IEC/IEEE 80005-1

AMENDMENT 1

**Utility connections in port –
Part 1: High voltage shore connection (HVSC) systems – General requirements**

Figure C.4 – Three-phase ship connector and ship inlet contact assignment

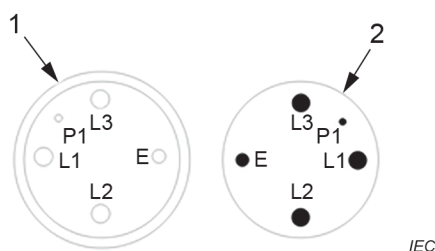
Replace the existing figure and key with the following new figure, key and note:

- 1 Ship connector face
- 2 Ship inlet face
- E Earth
- P1 Pilot line 1 (used for continuity check)
- L1 Phase A – phase R
- L2 Phase B – phase S
- L3 Phase C – phase T

NOTE Pins are shown as solid circles and sockets as open circles.
